UNITED STATES
DEPARTMENT OF THE INTERIOR
BUREAU OF LAND MANAGEMENTCarlsbad Field Office
EDD ArtesiaFORM APPROVED
OMB NO. 1004-0137
Expires: January 31, 2018Lease Serial No.
NMNM19848**SUNDRY NOTICES AND REPORTS ON WELLS**
Do not use this form for proposals to drill or to re-enter an
abandoned well. Use form 3160-3 (APD) for such proposals.**SUBMIT IN TRIPLICATE - Other instructions on page 2**

1. Type of Well <input type="checkbox"/> Oil Well <input checked="" type="checkbox"/> Gas Well <input type="checkbox"/> Other		8. Well Name and No. LAGUNA GRANDE UNIT 7H
2. Name of Operator CIMAREX ENERGY COMPANY Contact: ARICKA EASTERLING E-Mail: aeasterling@cimarex.com		9. API Well No. 30-015-42739
3a. Address 202 S. CHEYENNE AVE, SUITE 1000 TULSA, OK 74103	3b. Phone No. (include area code) Ph: 918-560-7060	10. Field and Pool or Exploratory Area PURPLE SAGE WOLFCAMP
4. Location of Well (Footage, Sec., T., R., M., or Survey Description) Sec 29 T23S R29E NWNE 180FNL 1650FEL		11. County or Parish, State EDDY COUNTY, NM

PECOS DISTRICT CONDITIONS OF APPROVAL

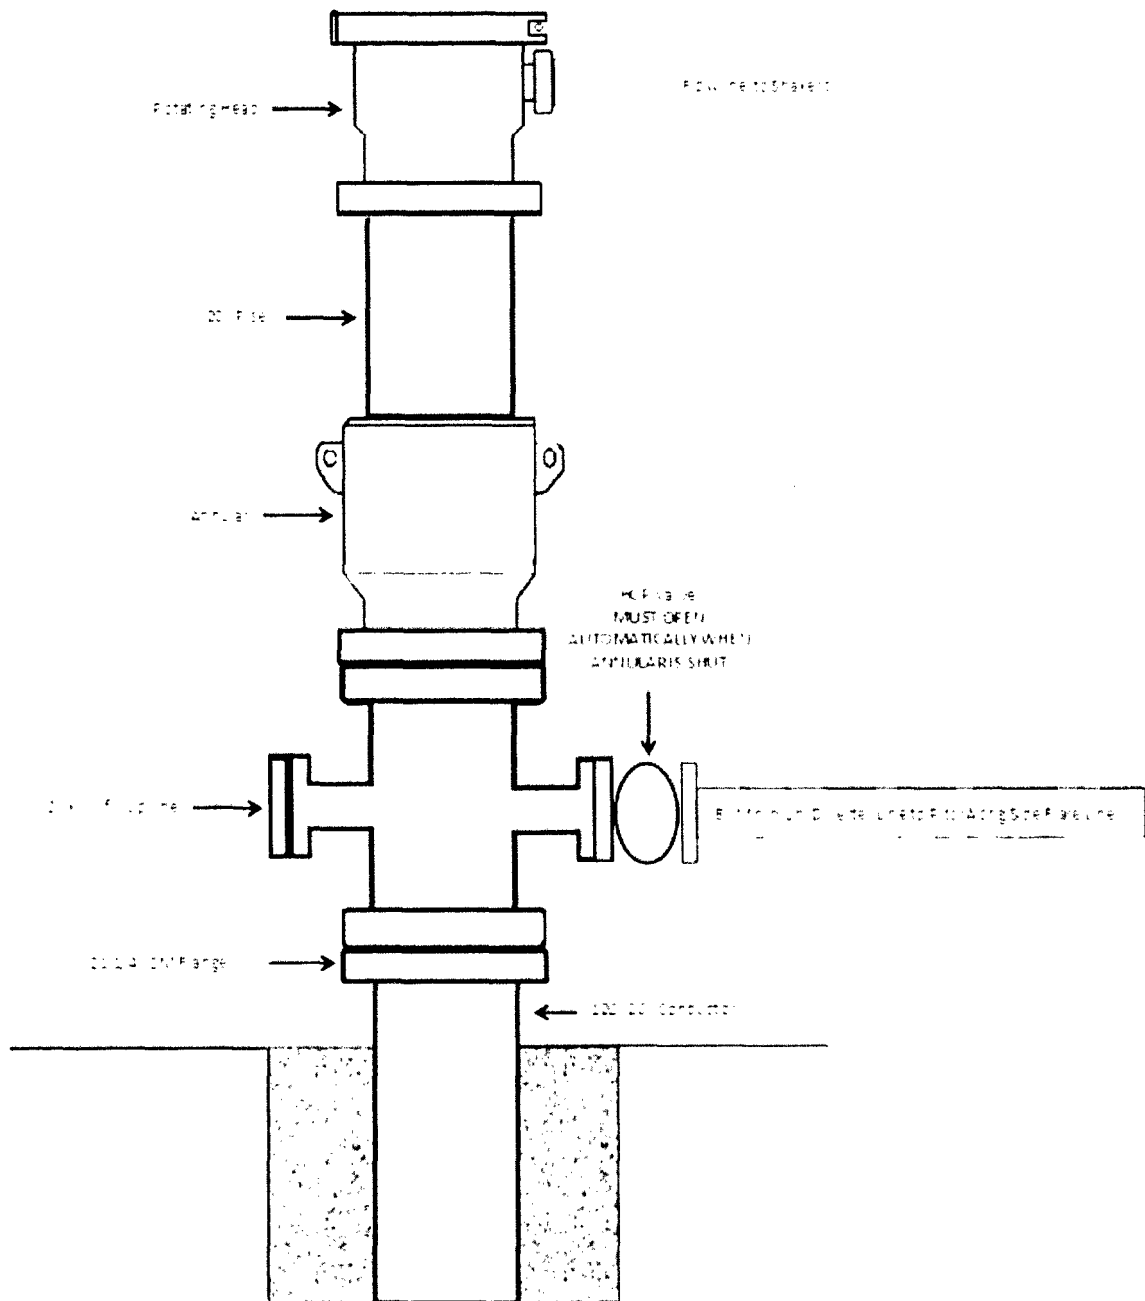
- Drill 30" hole with rathole rig to 150-165' from ground level (A conductor will not be set)
- Run and Set 20" 133# J-55 BTC casing. (
- Cement with 656 sacks of 14.8 ppg, 1.36 ft³/sack, 6.57 gal/sk, 500 psi = 9.5 hours, and Class C Cement. 100% excess. (This will be cemented conventionally with a plug system)

- WOC – 8 hours
- Release Rathole rig and Wait to MIRU with Drilling Rig
- MIRU Rig (Within 90 days)
- Weld on 21-1/4" 2M flange with mud cross, 21-1/4" 2M 20" annular and rotating head with 8" diverter line.

- Diverter System will be rigged up to simultaneously close the annular and open the HCR valve to divert flow from rig. This prevents any pressure from being applied to the 20" casing shoe.

- Function test system
 - No casing/BOP test will be performed.
- Drill 12-1/4" surface and set and cement 9-5/8" casing.
- WOC per COA.
- Cut off 20" casing and Nipple down 20" diverter system

- Weld on 11" 5M wellhead onto 9-5/8" casing.
- Proceed as current COA

1. The **20** inch surface casing shall be set at approximately **175** feet (a minimum of 25 feet into the Rustler Anhydrite and above the salt) and cemented to the surface.

Annular Diverter System

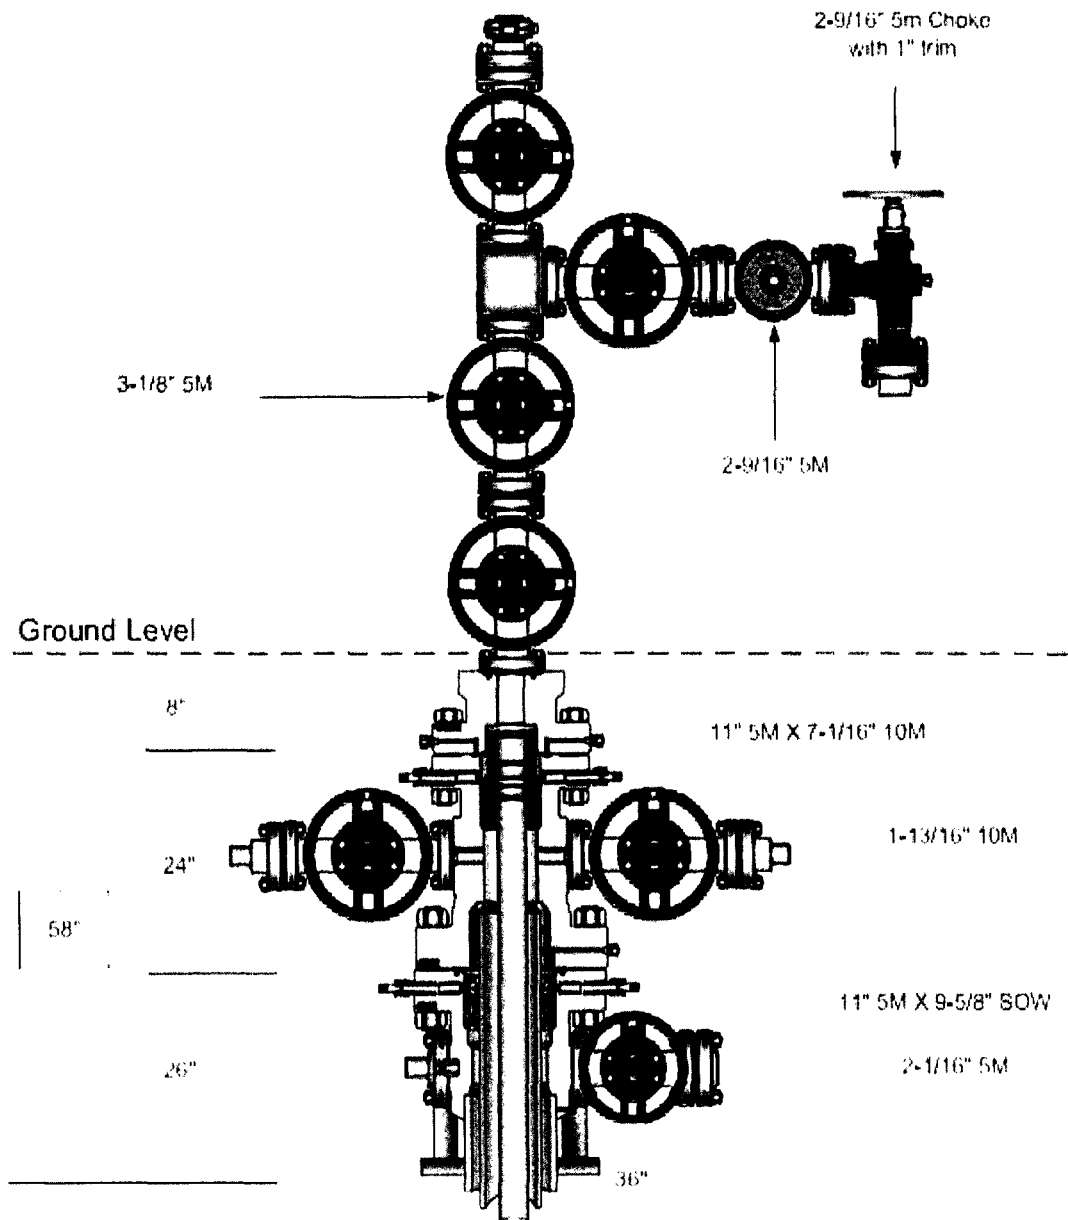
Cimarex requests a 20" Annular diverter variance to be used after setting 20" surface casing due to the shallow shoe of the 20" casing (175'). Our reasoning for not needing the BOP system is below:

- There is no hydrocarbon bearing zones below the 20" surface shoe and intermediate casing depth of 2,900'.
- Normally pressured gradient of 0.433 psi/ft = 1255 psi and this section will be drilled with 10# brine water which equates to 1508 psi of hydrostatic. We will be 283 psi over balance when drilling intermediate section.
- The system consists of a 21-1/4" flange welded to the 20" casing, 21-1/4" 2M mudcross with 2" kill/fill up line and 8" diverter line, 21-1/4" 2M annular preventer, 20" riser and rotating head bowl. See diagram below:

1. All blowout preventer (BOP) and related equipment (BOPE) shall comply with well control requirements as described in Onshore Oil and Gas Order No. 2 and API 53.
2. **A variance is granted for the use of a diverter on the 20 inch surface casing.**
